## Public Comment No. 1652-NFPA 70-2024 [ Global Input ]

This Global Public Comment is for CMP-12 to review the use of the terms "overcurrent", "overcurrent protective devices" and "overcurrent protection".

**CMP-10 TG-4 Review of Overcurrent Language for the Articles under the purview of CMP-12**

~~Figure Informational Note 620.62 Selective Coordination for Overcurrent Protective Devices Supplying More Than One Elevator.~~

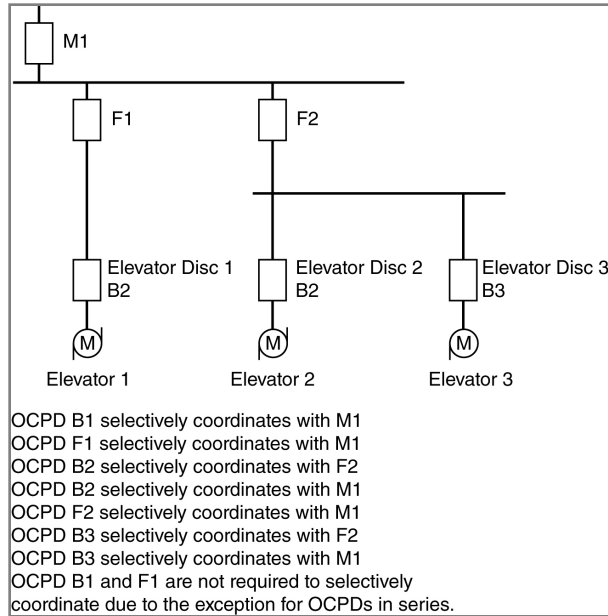
Please note that it is NOT my intent to delete this drawing, but rather to point out the problem with it. The drawing indicates that OCPD B1 coordinates with M1. The problem is...there is no B1 in the drawing. The disconnect on the left is probably supposed to be B1, but instead two of the three disconnects are marked as B2. I know of no way in Terraviv that I can fix this, other than to just point it out to the CMP.

**Committee Action:** Rejected but see related SR  
**Resolution:** [SR-7820-NEPA 70-2024](#)  
**Statement:** The change to the overcurrent device terminology is for consistency throughout the code. The revision to the figure corrects an error in the figure as the B2 under Elevator Disc 1 in the figure should be B1.
